## DS-K1T341A Series MinMoe Terminal

### Release Notes (2022-03-09)

<b>Device Model:</b> DS-K1T341AM DS-K1T341AMF	Firmware Version	ARM: ACS_641_AI3_EN_ <b>STD</b> _V3.2.30_build220210 ACS_641_AI3_EN_ <b>NEU</b> _V3.2.30_build220210
	SDK	Latest version
<b>Naming Rule:</b> M for M1 card, F for fingerprint	iVMS-4200 Client Version	Latest version baseline

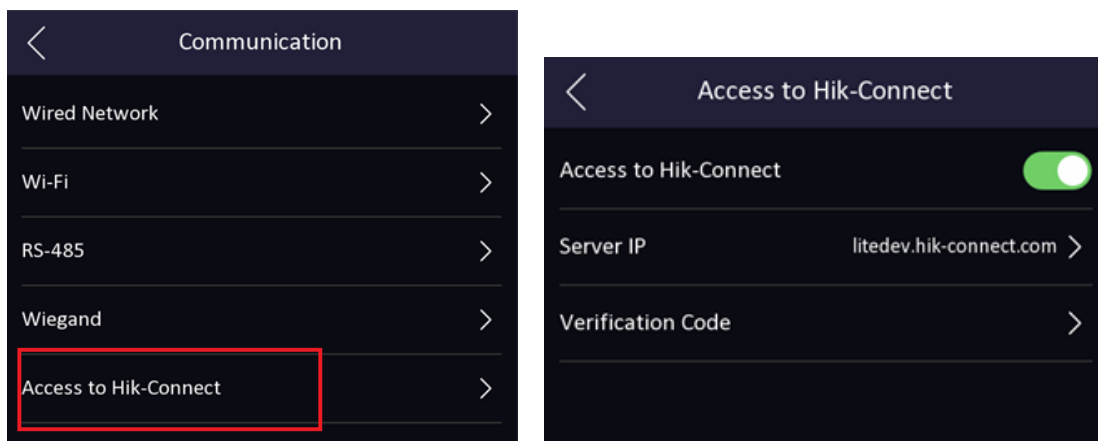
1. Add Hik-Connect menu in device UI Menu → Comm. The function is disabled in default.

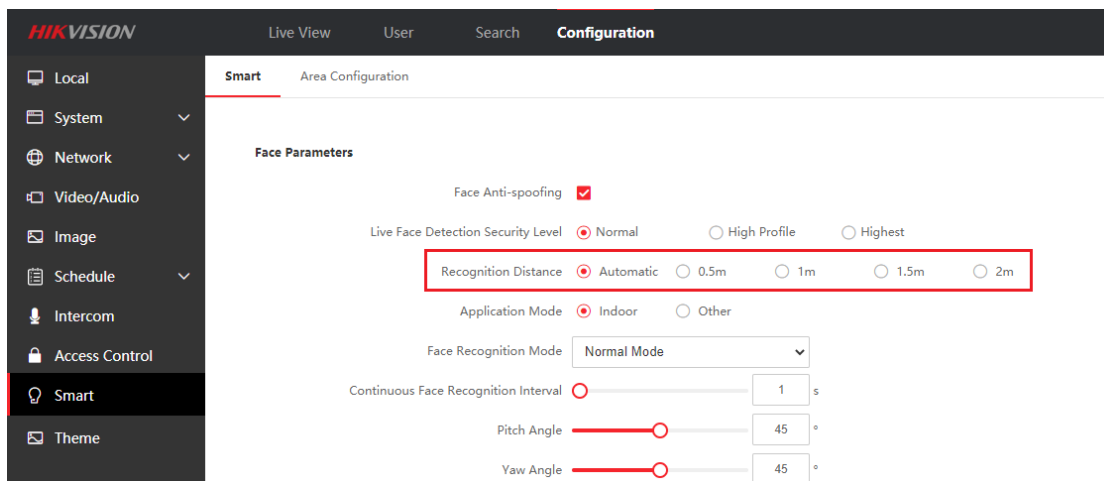
1. Optimize the wake-up distance of the device screen through the face, and the wake-up distance is consistent with the recognition distance
